QUATTROCCHI KWOK
ARCHITECTS

PARKWAY HEIGHTS MIDDLE SCHOOL MODERNIZATION – PHASE II
PROJECT 01-18

Addendum 02

FEBRUARY 21, 2018

SHEET NUMBER
ADD 02
02.15
A-3.1

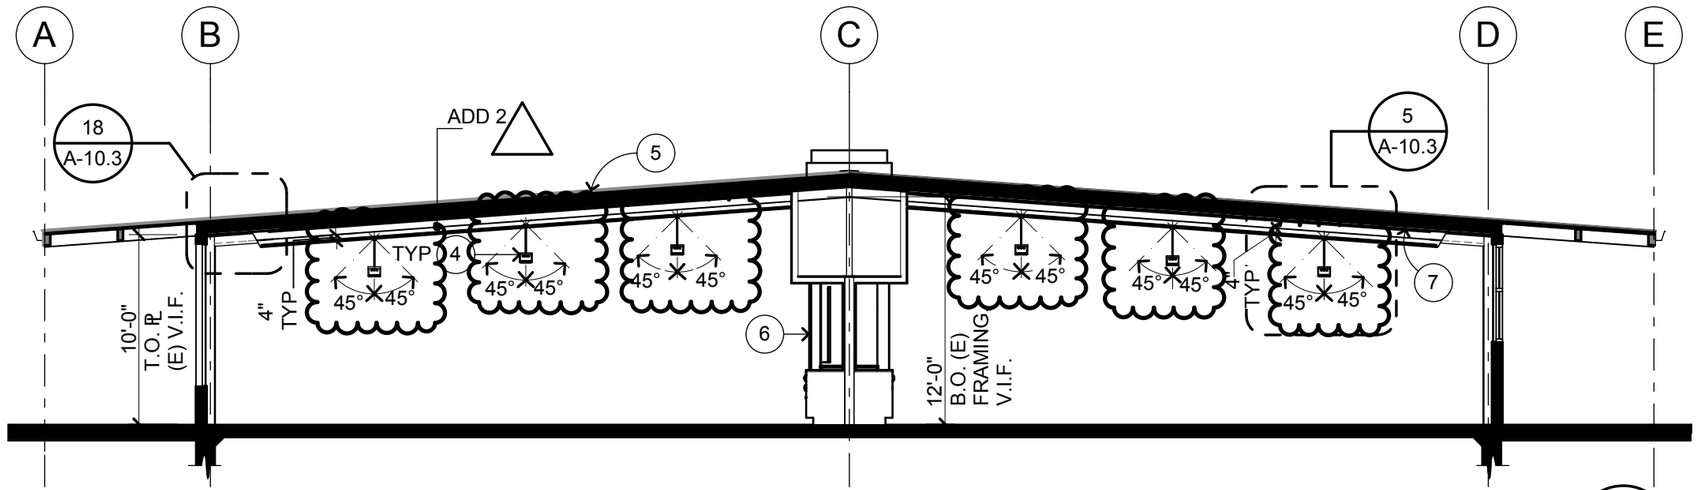
Item No. 2.02
Sheet A-3.1 Reflected Ceiling Plan
Revision to suspended ceiling grid layout and light locations: See Add 02.15

Item No. 2.29
Sheet A-3.1 - REFLECTED CEILING PLAN
Revision to grid and light locations: See ADD 02.15

FLOOR PLAN - LIGHTING

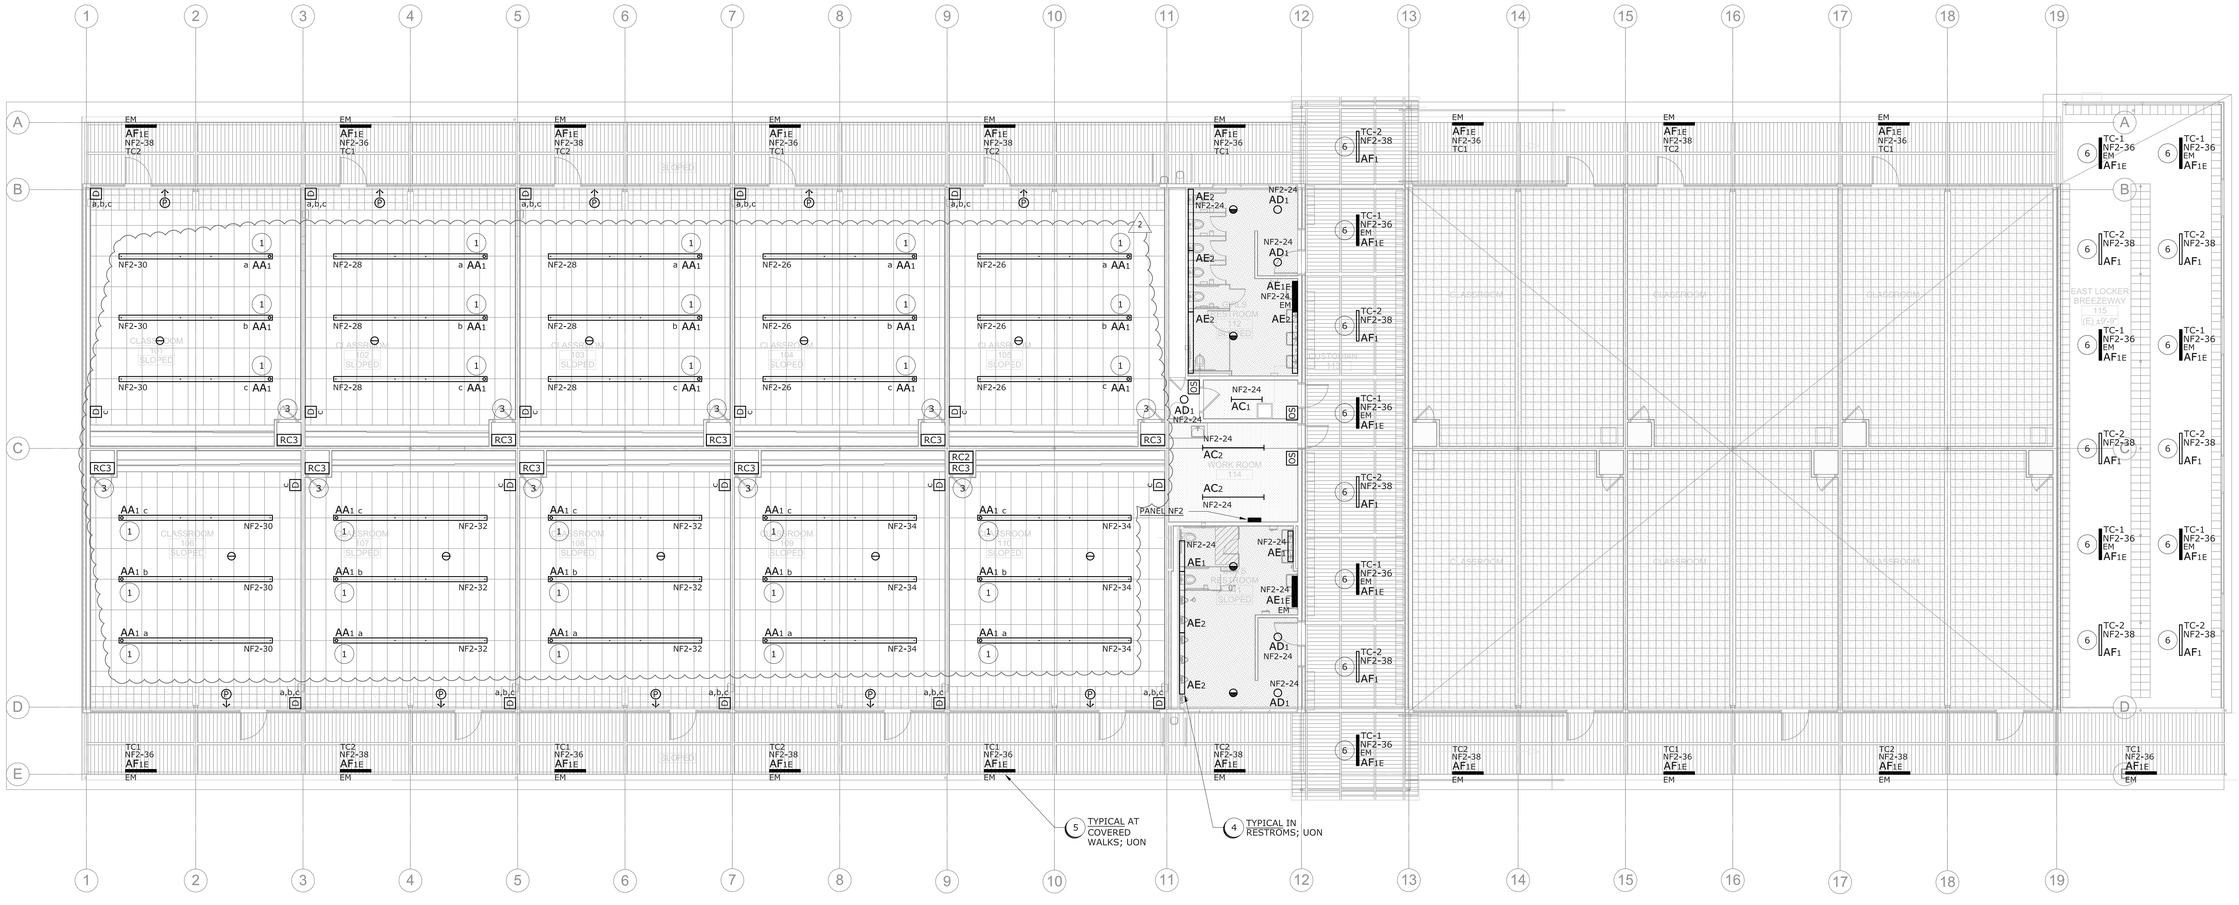
Item No. 2.32
E-2.1 – FLOOR PLAN – LIGHTING
Provide lighting as indicated. Modifications clouded and marked delta 2. See ADD 2.18.

PENDANT LUMINAIRE: ON-GRID MOUNTING - T-BAR/SUSPENDED CEILING

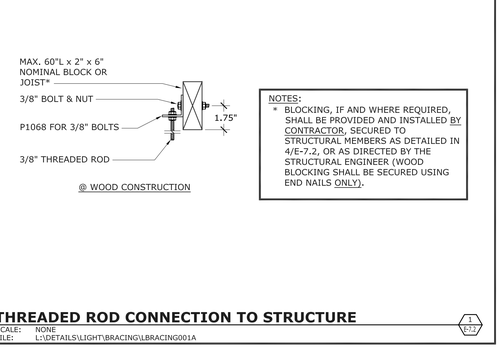
Item No. 2.33
E-7.2 – DETAILING
Delete detail 9.
Detail 5 revised to address suspended ceiling fixture mounting. See ADD 2.19.

SHEET NUMBER
FE-0.1
ADD 02.20

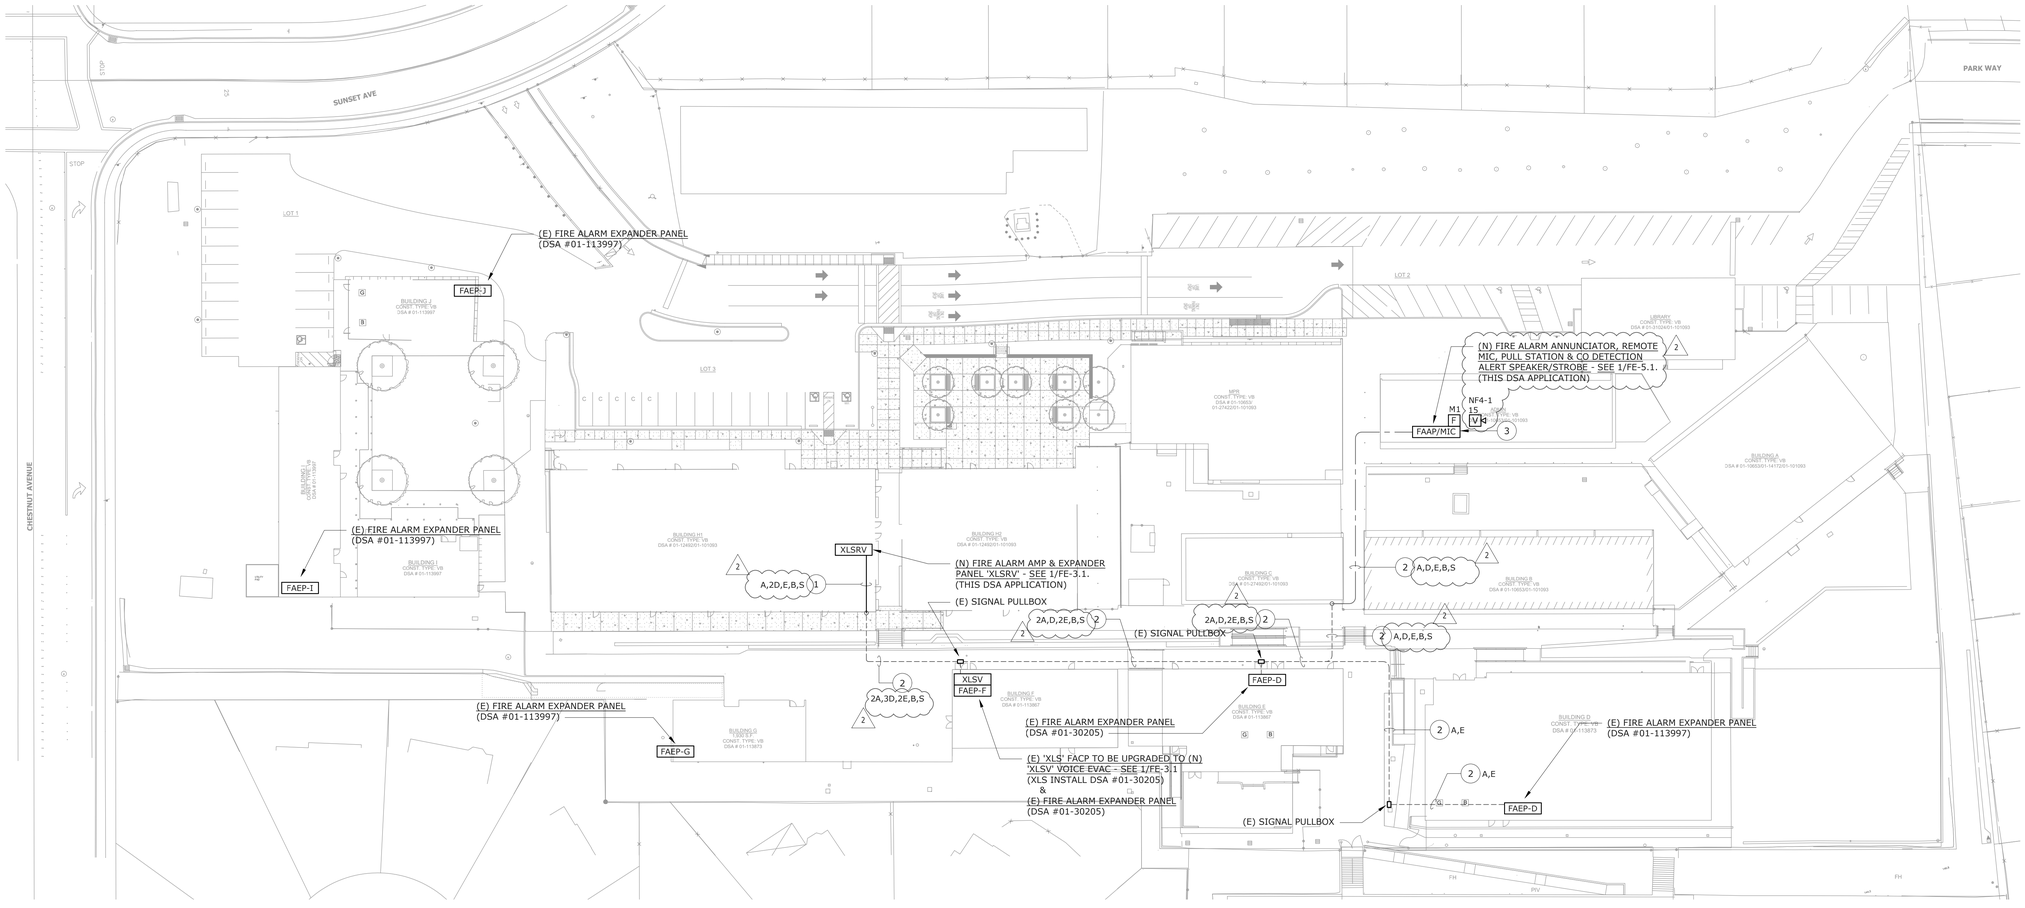
Item No. 2.34
FE-0.1 – FIRE ALARM EQUIMENT LIST & GENERAL NOTES
Provide provisions as indicated related to CO detection requirements. Modifications clouded and marked delta 2. See ADD 2.20.

FE-3.1
ADD 02.22

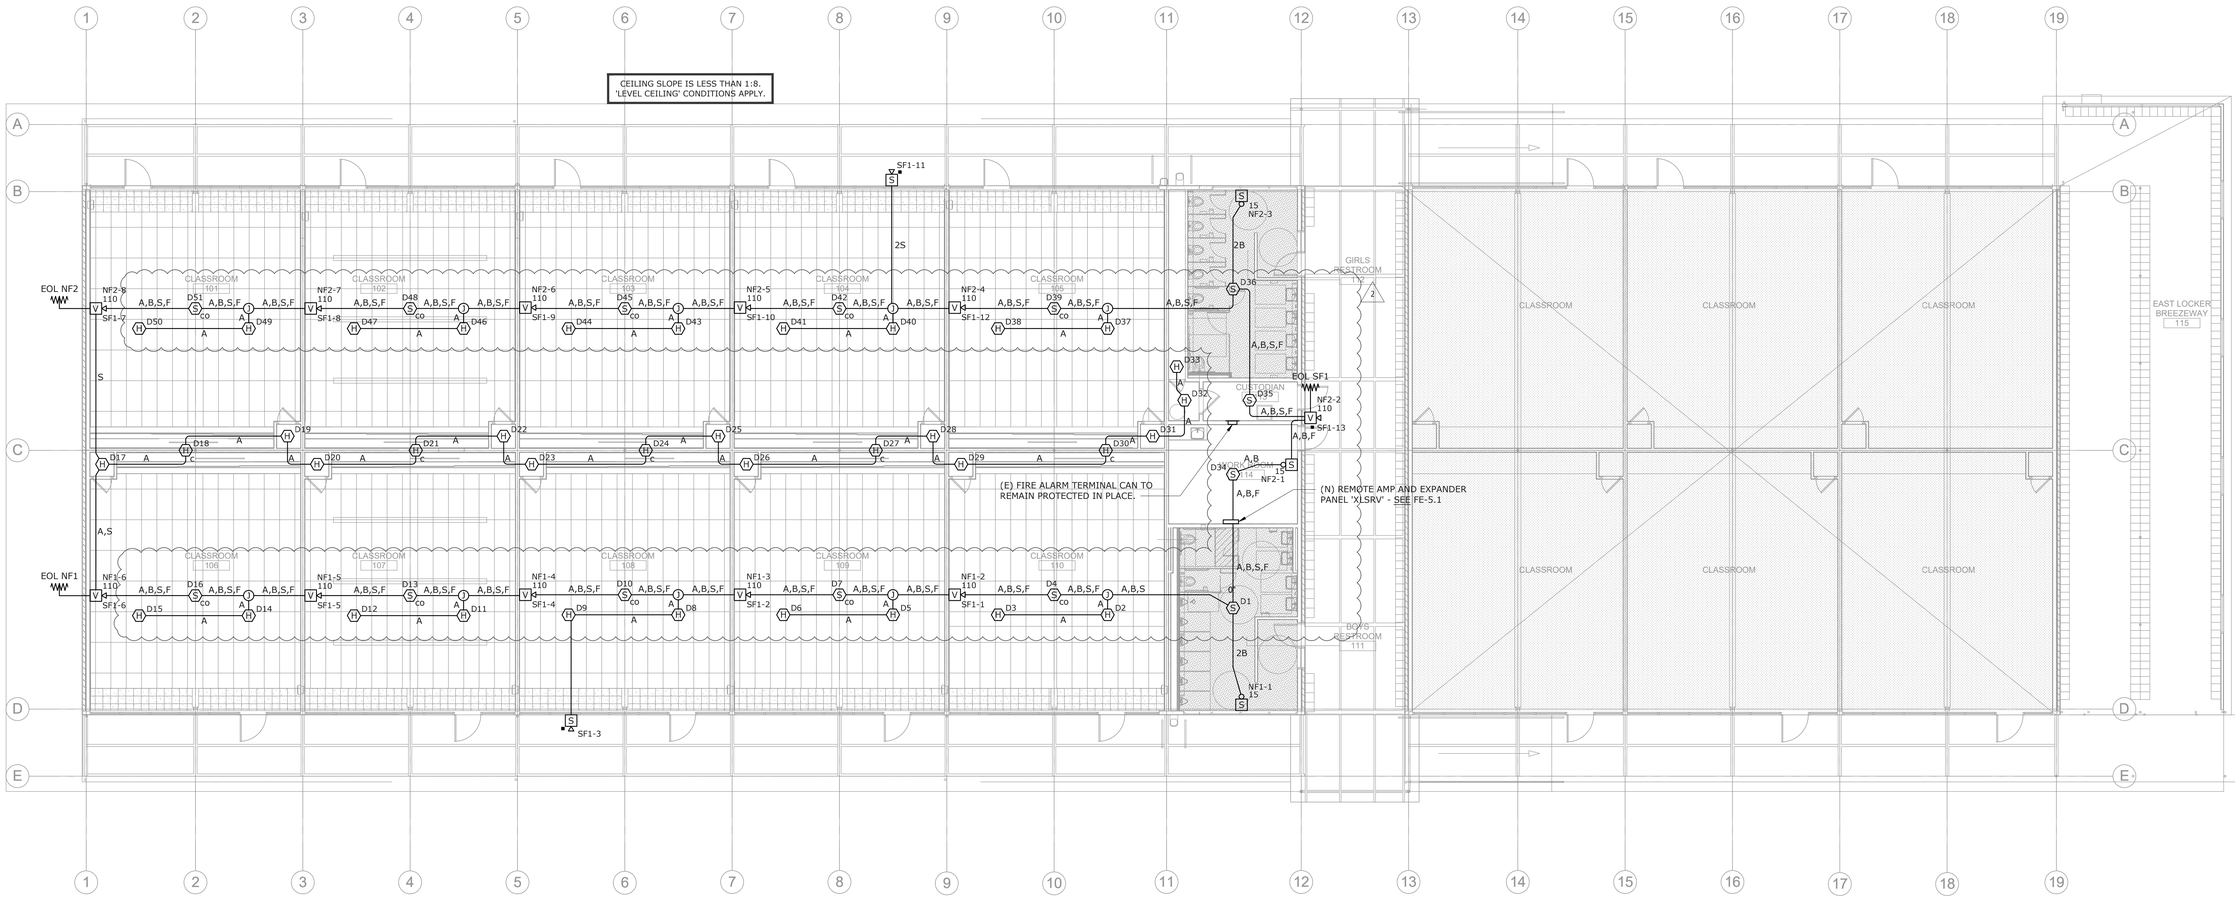
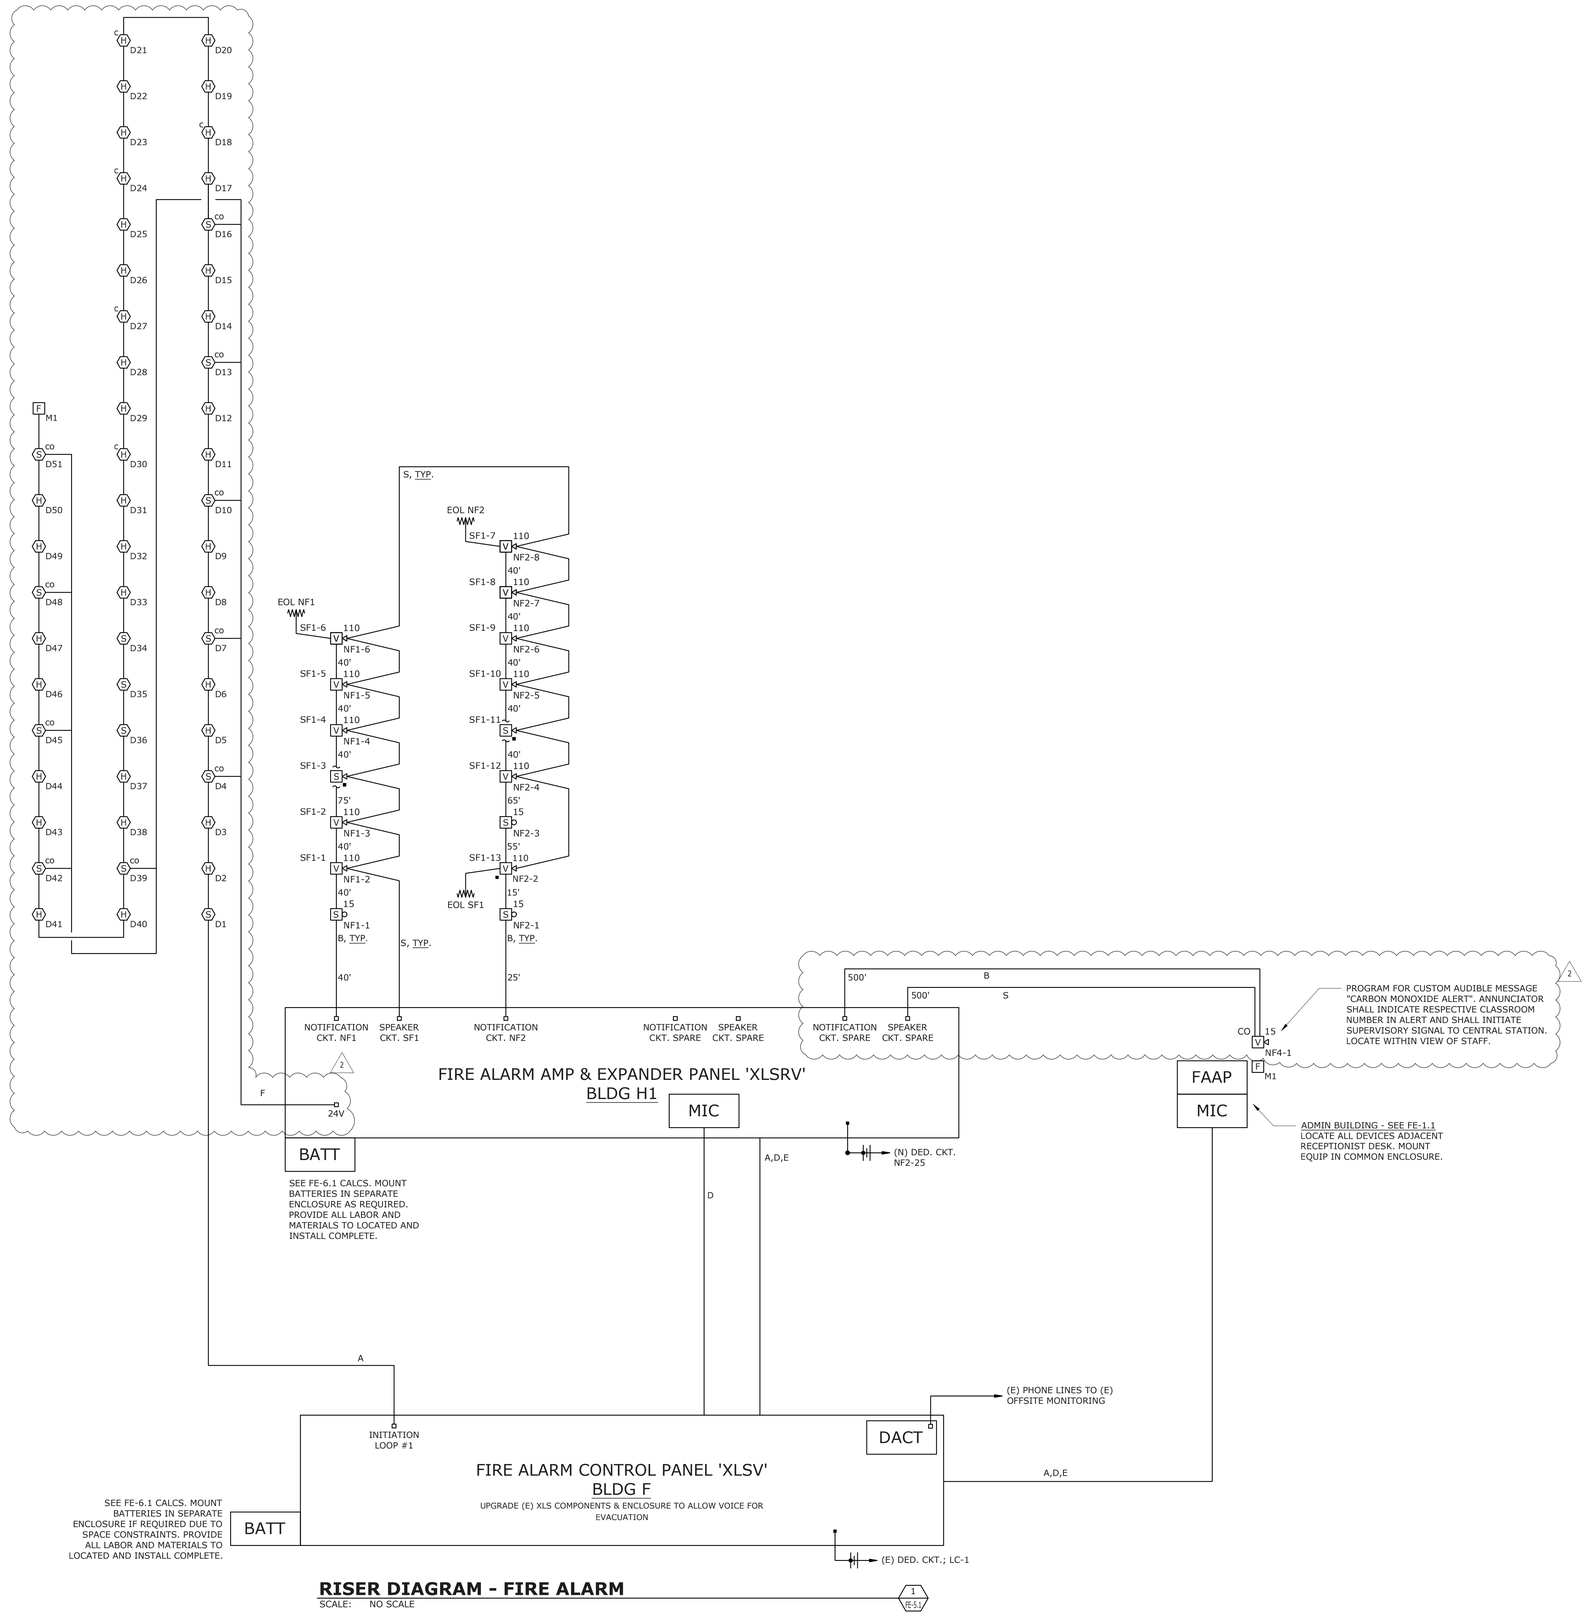
Item No. 2.36
FE-3.1 – FLOOR PLAN FIRE ALARM
Provide provisions as indicated related to CO detection requirements and above suspended ceiling detection. Modifications clouded and marked delta 2. See ADD 2.22.
